THE CORPORATION OF THE CITY OF COURTENAY

MEMORANDUM

To: Chris Marshall, Director of Development Services
From: Cassandra Marsh, Planner I
Subject: Application for Development Permit at 470 Leighton Avenue

Date: June 9, 2022

Figure 4. Site plan with parking shown in yellow.

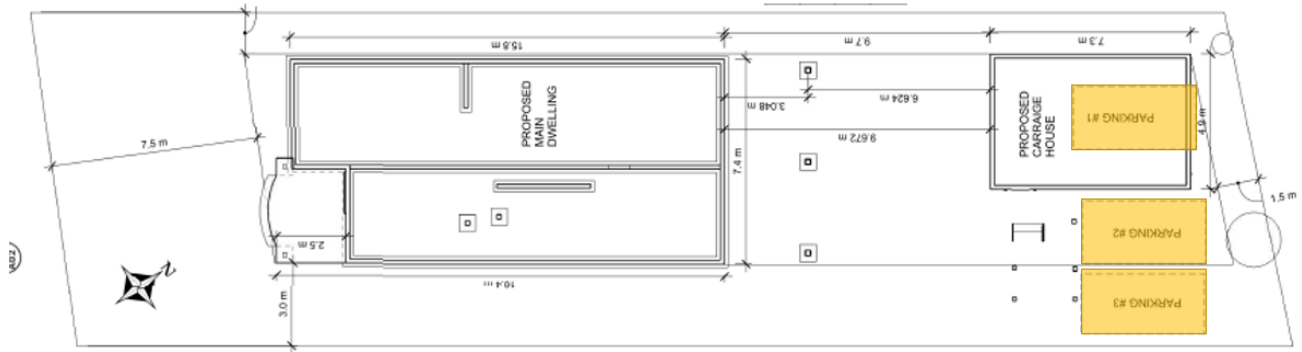
The main building is proposed to be sited closer to the front of the lot, allowing ample space between residences, while the carriage house is situated near the lane for easy access. Both are oriented towards Leighton Avenue. Parking is proposed in the rear, off of the lane, shown in **Figure No. 4**). No trees are proposed to be cut for this development. The applicant is proposing that the gravel parking and garage access be sited around the existing Fir trees in the rear. Existing landscaping will be retained and additional landscaping is proposed as shown in **Figure 5**.

A review of the applicant's site plan demonstrates that the proposed single family dwelling and carriage house comply with the requirements in R-2B Zone.
